BULLETIN: CA-SB-19-D-73-70
DATE: 11/23/73
PAGE: 1 OF: 3

19DG HERMETIC CENTRIFUGAL INTERNAL AGITATOR ASSEMBLY

PURPOSE: To relate information concerning a possible sticking problem with the internal agitator assembly.

FIG 1

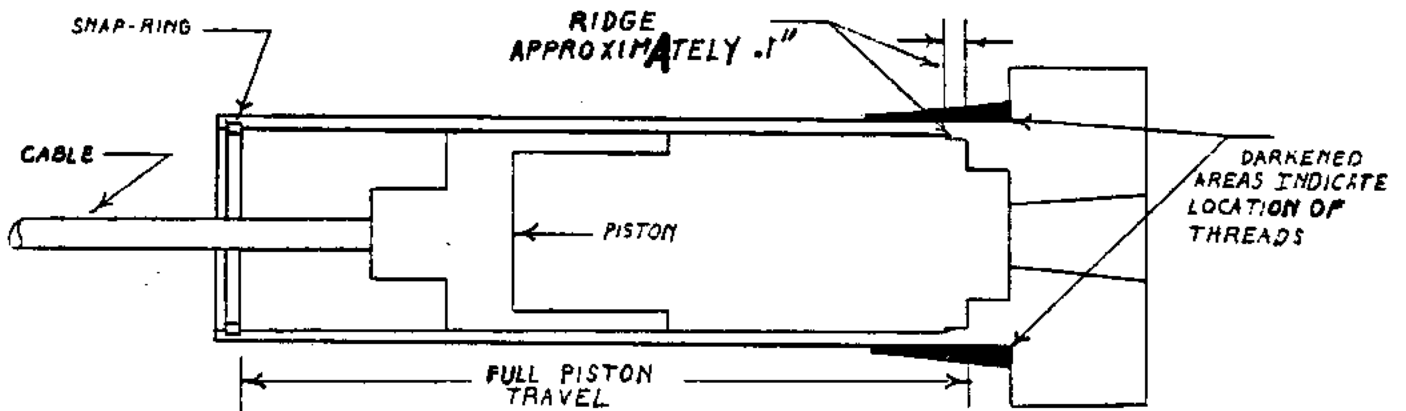
Remove the agitator assembly. Remove snap ring from end of assembly and remove piston. At the bottom of the housing, there may be a slight step or ridge, (see fig. 1) located approximately 0.10 inch from the bottom of the housing. This ridge exists because the reamer does not bottom completely. Also, tightening the agitator assembly in the float chamber causes the thin-walled housing to contract slightly. As a result, a negative clearance is encountered between the piston and the ridge in the housing, and the piston may remain stuck. Excessive tightening may cause the piston to bind even before it reaches the ridge.

Another method available is to cut or file a slight chamfer on the piston. (See fig. 2.) This chamfer should be approximately 1/8 inch wide, and deep enough to clear the ridge.

Loosening the assembly from the float chamber will sometimes be enough to free the piston and render the unit operational. Using this method requires use of additional thread sealant during reassembly to insure against leakage.
